SAN LUIS OBISPO COUNTY  
**DEPARTMENT OF PUBLIC WORKS**

November 25, 2015

**ADDENDUM NO. 2 TO  
COUNTY SERVICE AREA NO. 16  
STATE WATER PROJECT TURNOUT  
SHANDON, CA  
CONTRACT NO. 300463**

**7 | REMOVABLE BOLLARD**

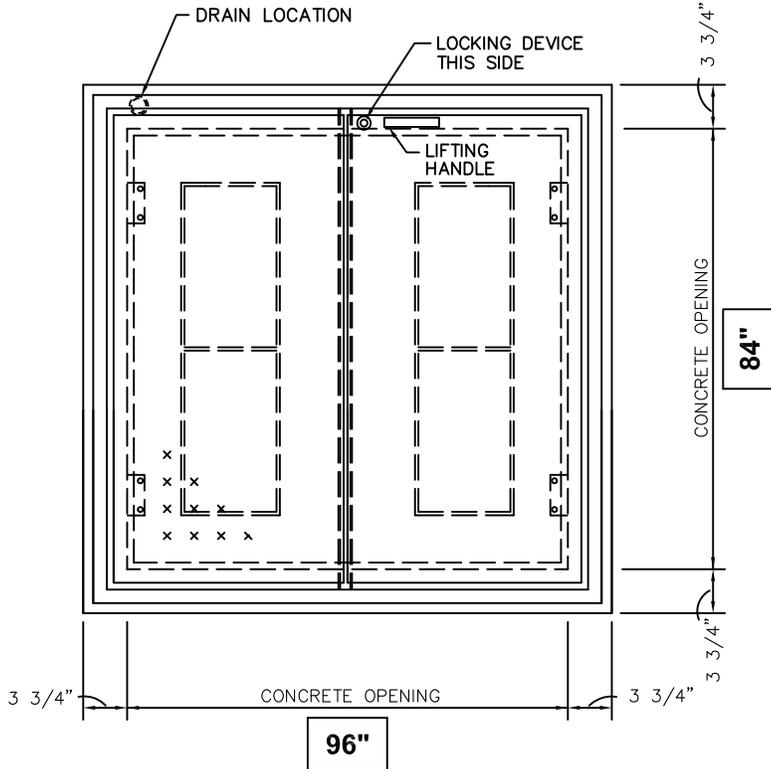
“INSTALL FOUR (4) REMOVABLE BOLLARD PER DETAIL 7, SHEET 8. LOCATIONS TO BE DETERMINED IN FIELD BY THE ENGINEER”
- 13) On Sheet 8 of 15, “Details,” add detail 7, REMOVABLE BOLLARD per attached detail.

- A. Provide Knox-box padlocks per City Fire Department.
- B. Provide 5' clear spacing between bollards (5'-3" O.C.) for bicycling facilities. For all other installations, provide 4' clear spacing between bollards (4'-3" O.C.)
- C. Use play booster by Landscape Structures Inc. distributed by Rec West (818) 735-3838, South Bay Foundry DFB-RA5 or approved equal.

**NOTE:** All steel to be double coated galvanized.

MODEL NO. W2S096084CBD-----  
 QUANTITY: 1  
 ORDER NO. Q48306  
 DATE: 11/25/15  
 LOCATION/TAG: SHANDON SWP

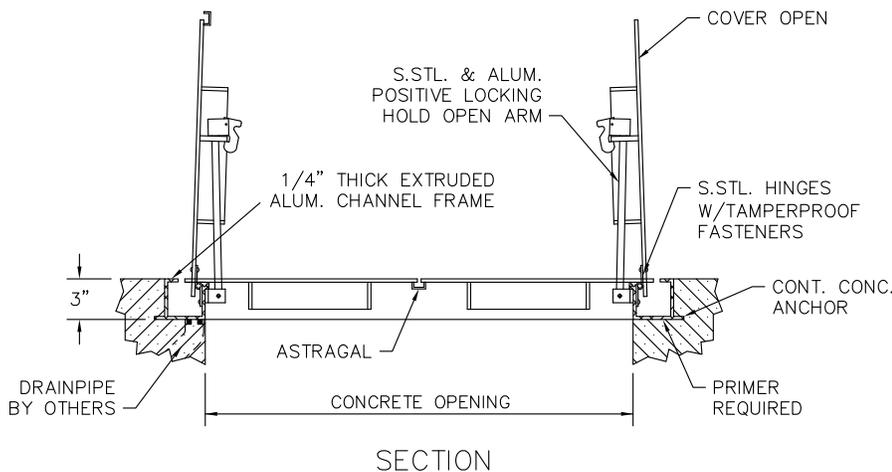
- 4) In section 05 53 00 “Grating, Cover Plates, and Access Hatches”, Part 2, paragraph 2.03 “Floor Access Hatches”, change paragraph A to read as follows:
  - “A. Manufacturers of Prefabricated Floor Access Hatches (custom order – see sample cut sheet for informational purposes only at the end of this section):
    1. Bilco Company.
    2. Halliday.
    3. Babcock-Davis Associates, Inc
    4. Thompson Fabrication Company.”
- 5) In section 05 53 00 “Grating, Cover Plates, and Access Hatches”, a sample product cut sheet for the custom order aluminum access hatch from one of the manufacturers, Halliday Products, is attached to the end of the section for informational purposes only.
- 6) In section 32 31 13 “Chain Link Fences and Gates”, Part 2, paragraph 2.02 A, change the paragraph to read as follows:

“7’-0” X 8’-0” DOUBLE LEAF ALUMINUM ACCESS HATCH”
- 12) On Sheet 3 of 15, “Site Plan,” under the table entitled “Notes”, add item 7 to read as follows:
